AMENDMENT No. 2

Contract Agreement No BIDSF-020-02-01-00

Substation Bystričany – transformation 400/110 kV, Substation Horná Ždaňa – enlargement, Substation Križovany – enlargement

Engineer's Determinations

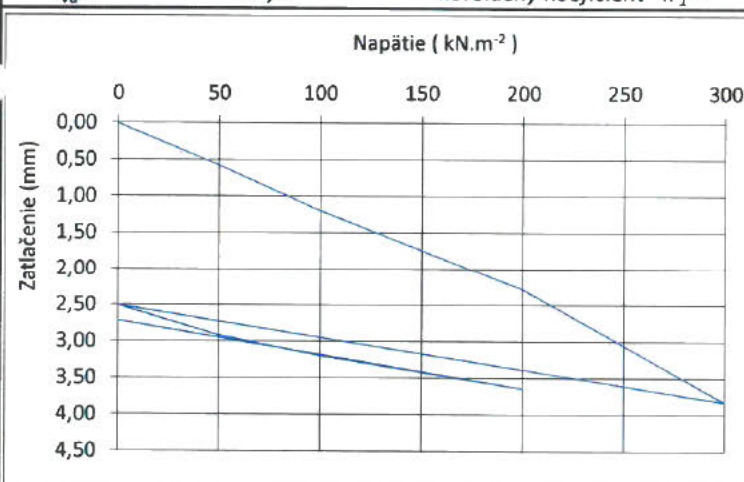
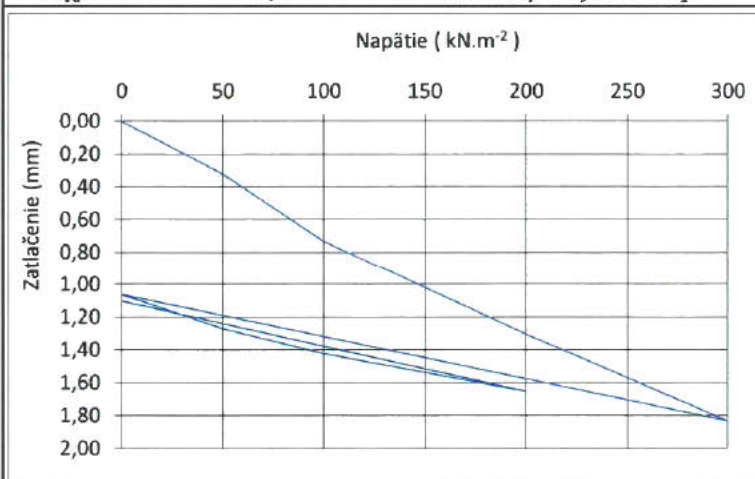
During soil bearing capacity measurements for SO681 Temporary access road, as requested by Tender documents (TD) (*measurement report – attachment no.3*), were more severe conditions found than stated in TD. Variation of geological conditions along the planned access road and retaining wall were found. Original geological survey (OGS) by RNDr. Mikuš Pavol as of 17.09.2014 states higher soil bearing capacity than measured before construction. OGS states on page 6 following: *„Designated area may contain descending underground water streams flowing across the area. It is necessary to point out that location and amounts of flowing water varies according to season and actual weather conditions. Streams may occur on spots, where probes were made and no stream was found, also they may disappear from spots where they have been found. “*. That means that occurrence of water negatively affects soil bearing capacity.

humus topsoil will be spread back. After execution of earthmoving works on the plane in required extent and excavation for designed road, it will be necessary to compact the road surface to the compact degree $E_{def2} = 60 \text{ MPa}$. It is necessary to prove the compact degree of the road plane and other compacted layers by performing static and dynamic load control tests, which number for each compacted layer must be more than 3. The tests must be performed also at places of filling of utility networks. Contractor of ground works is obliged to document to the project investor the test results, which he will consult with site supervisor and responsible designer. Even after that it will be possible to build up single structural parts of the road. In case that required compact degree of the subsoil is not reached, it will be necessary, after confirming by geotechnical expert, to perform suitable technical measures. “, The Contractor performed such measurements. He was unable to reach required compaction values, due weather and soil conditions. Geotechnical measurement protocols are attached. (attachment no.3). These measurements were repeated twice. Also, underground lines not indicated by the DDT were found in the place of the road.

Remedial measures were taken according to Geo-technician’s recommendation, new road layers composition is designed. Below described solution will provide requested road bearing capacity and sufficient protection of the underground lines.

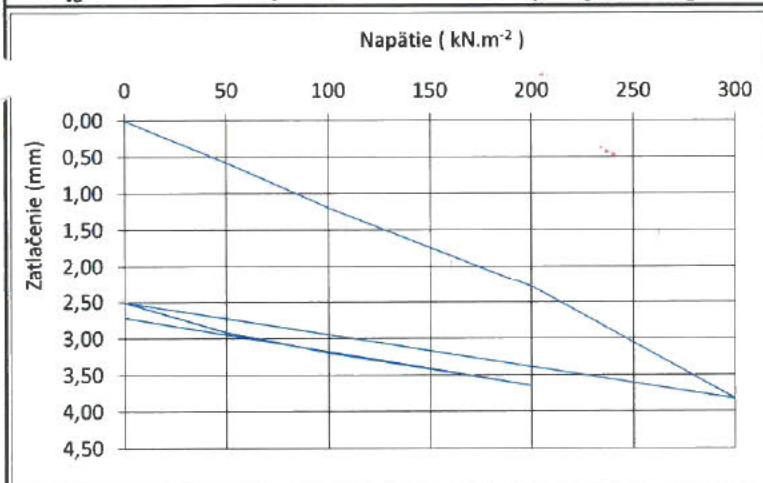
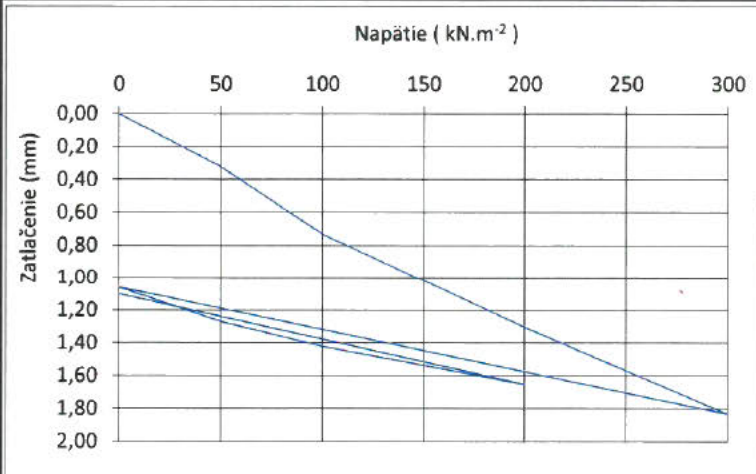
During soil bearing capacity measurements for SO681 Temporary access road, as requested by Tender documents (TD) (*measurement report – attachment no.3*), were more severe conditions found than stated in TD. Variation of geological conditions along the planned access road and retaining wall were found. Original geological survey (OGS) by RNDr. Mikuš Pavol as of 17.09.2014 states higher soil bearing capacity than measured before construction. OGS states on page 6 following: „Designated area may contain descending underground water streams flowing across the area. It is necessary to point out that location and amounts of flowing water varies according to season and actual weather conditions. Streams may occur on spots, where probes were made and no stream was found, also they may disappear from spots where they have been found.“ That means that occurrence of water negatively affects soil bearing capacity.

- a) Reinforcement steel amount increase by 13,1 tons to provide higher total firmness of retaining wall.
- b) Modification of retaining wall shape, angled structures were replaced by rectangular structures.
- c) Drainage layer was strengthened to provide improved occurring water drainage. New anti-frost wedges were created including enhancing of clay soil compaction.
- d) Shape modification also caused increase of length of drainage holes to provide drainage of water from the hill held by the retaining wall.
